Subject: RE: OrePac Clarification Items

Consent of All Adjoining Properties and 2/3 of Affected Properties ORS 271.080 (2)

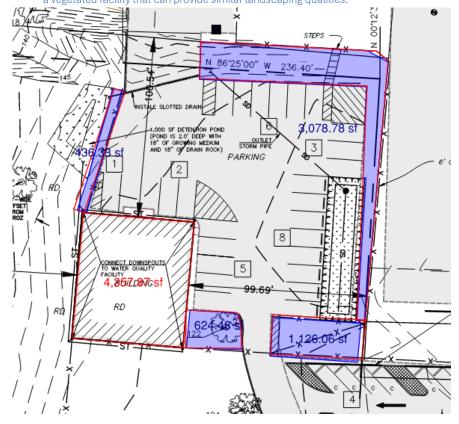
- Parking Lot Landscaping Section 4.155 (.03) B.: Why are there no landscape islands or landscaping proposed (Sheet L1.10) in the new northern parking area? Are existing trees along the north and east sides being considered parking lot landscaping? That is correct, the areas in blue boxed in the image below are considered as landscape islands and are provided at an aggregate from the northern parking lot area. The impervious area of the L-shaped parking area is ~15,850 SF, and approximately ~5,200 SF of parking area landscaping is provided, satisfying the 10% requirement. These areas have mature trees which will provide shade to the parking area. Additionally, the new storm facility in the northern parking area is a vegetated facility that can provide similar landscaping qualities.

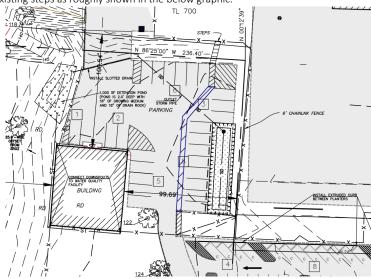
a. As part of the permitting documents, we anticipate providing a marked path through the parking lot, to tie into the existing steps as roughly shown in the below graphic:
